Docket Item # 6 & 7
BAR CASE # 2012-0101 & 102

BAR Meeting
July 25, 2012

ISSUE: Permit to Demolish/Capsulate &
Certificate of Appropriateness

LOCATION: 804 Duke Street

EXISTING ELEVATIONS

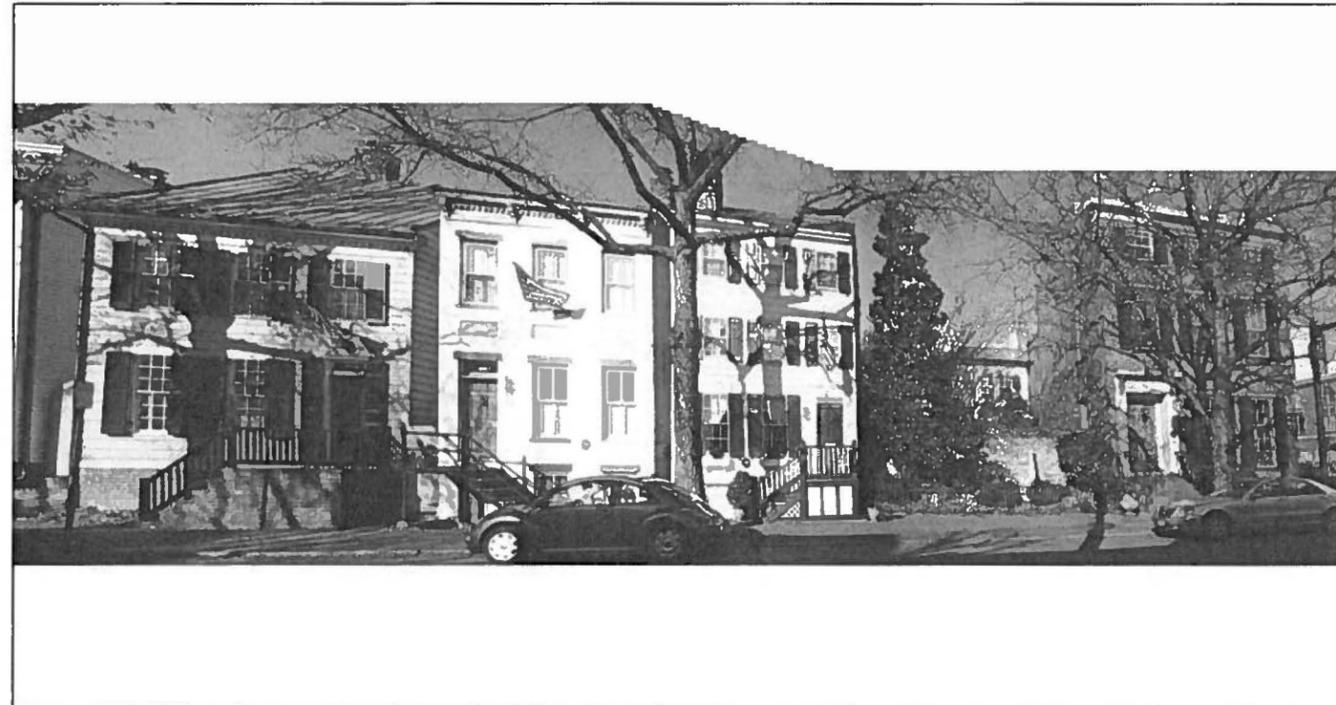
- Capsulate approximately 120 sq. ft. of wall area on the east/side elevation of the 1896 brick extension.
- Change two, existing windows on the east/side elevation into doorways by demolish approximately 9 sq. ft. of brick.

The proposed enlarging of the existing window openings are appropriate IF the applicant retains the existing segmental arches in the design. Retention of these historic arches provides evidence of the original window width and the opportunity in the future to return the elevation back to its original configuration if a future homeowner determines that an elevator is no longer needed.

PROPOSED ELEVATIONS

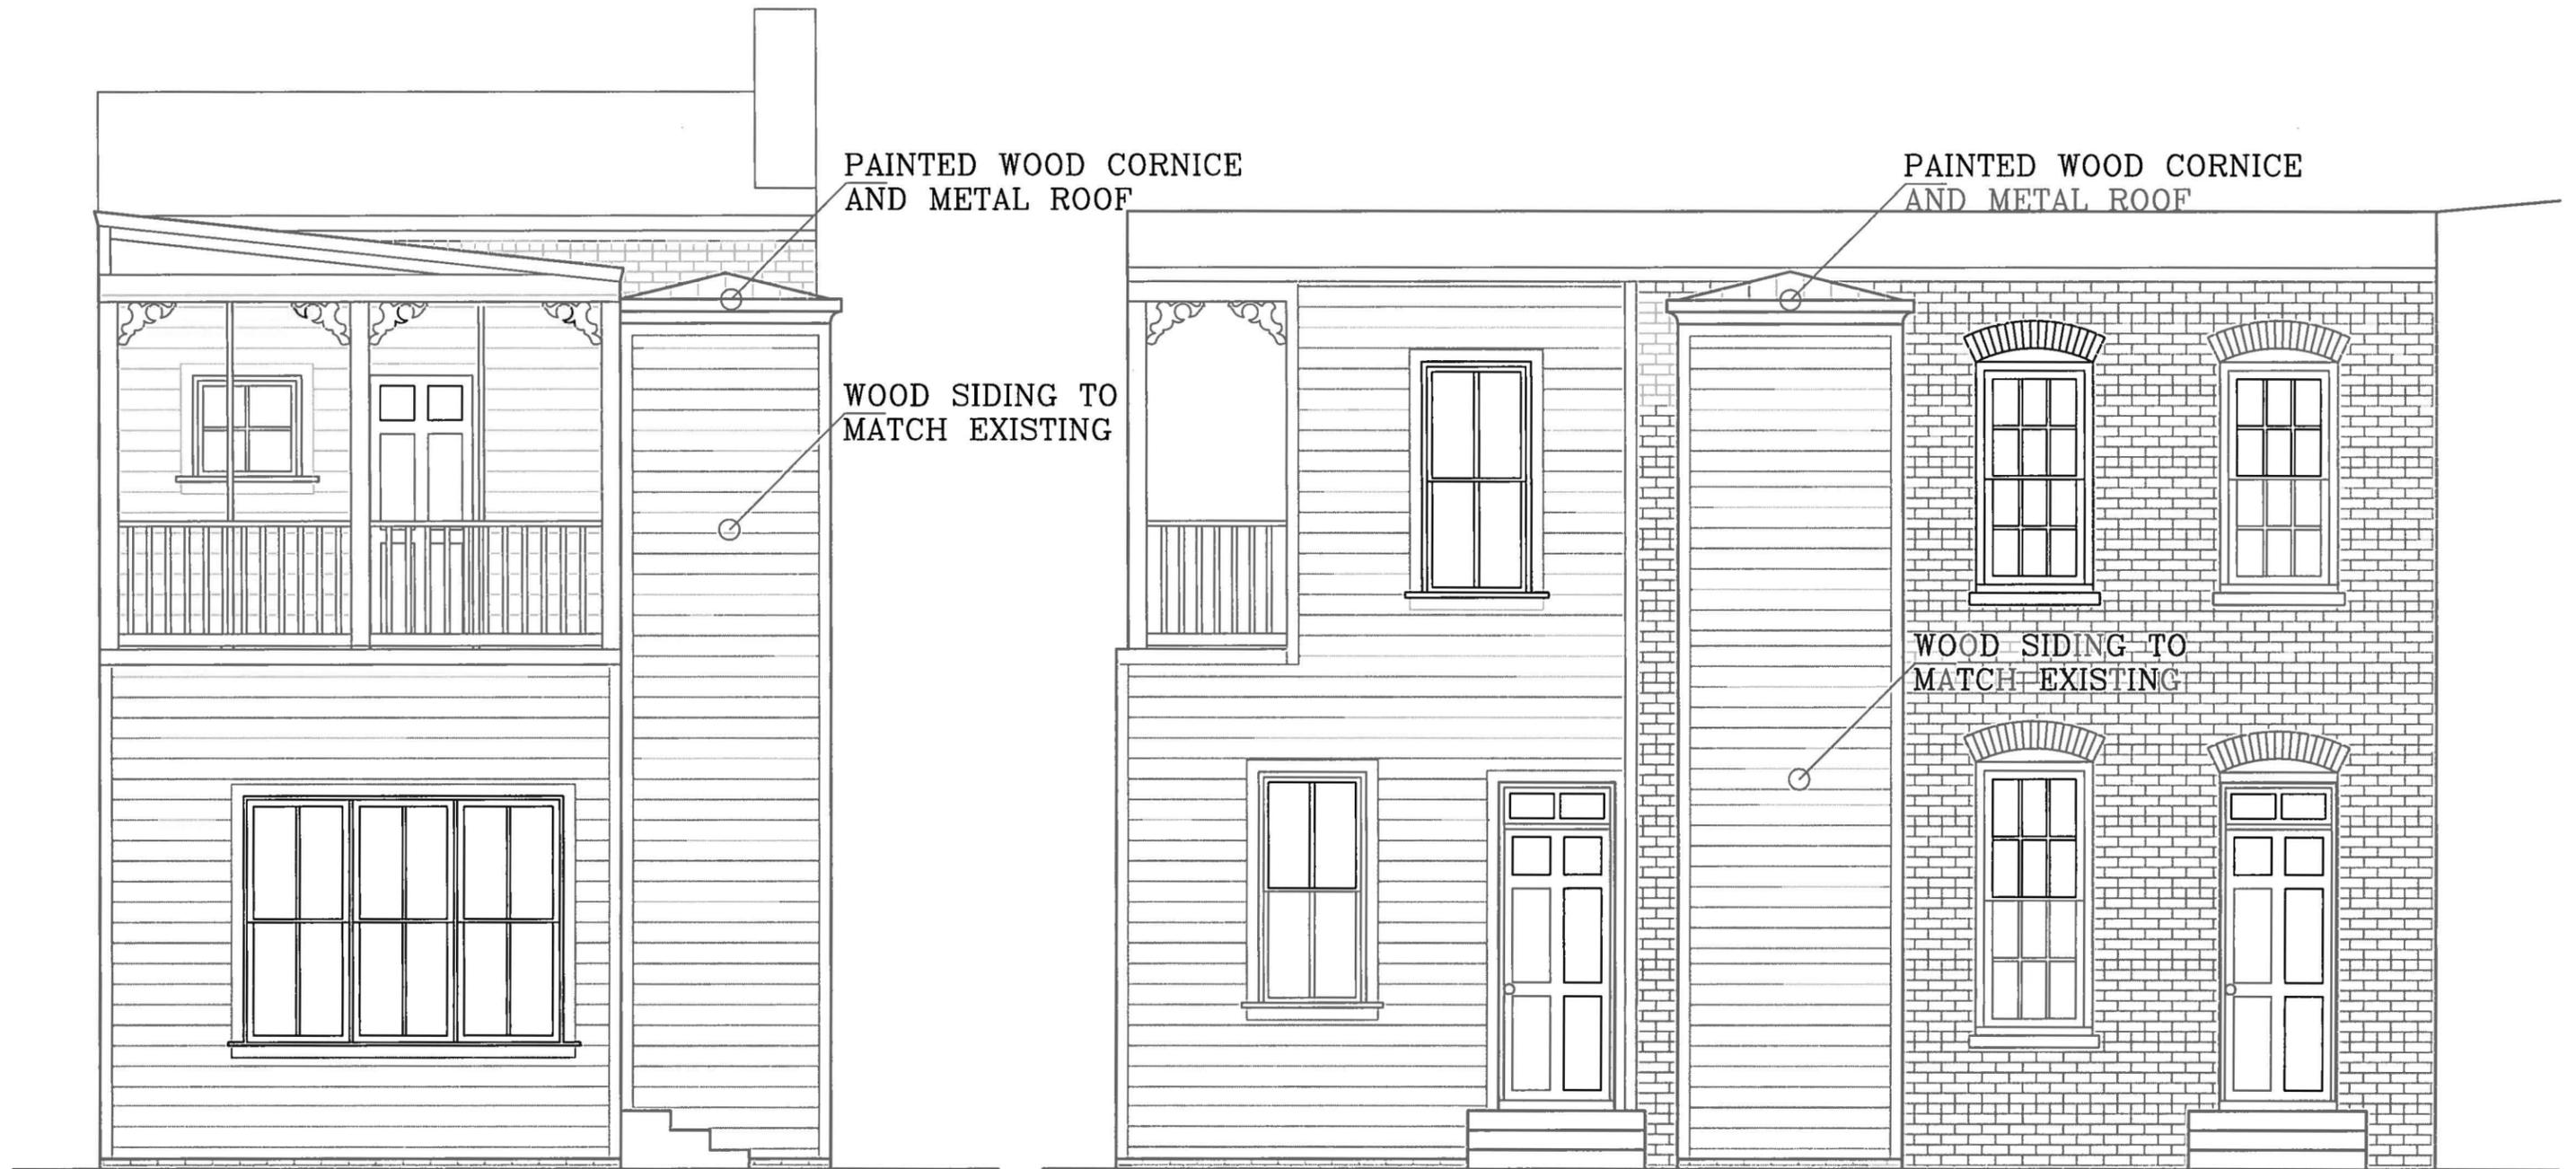
STAFF RECOMMENDATION: Staff recommends approval of the Permit to Demolish/Capsulate and Certificate of Appropriateness application with the condition that the segmental arches are retained on the windows proposed to be enlarged into doors.

The proposed materials — wood siding/trim and standing-seam metal roofing — are all considered by BAR policies appropriate materials for new construction.
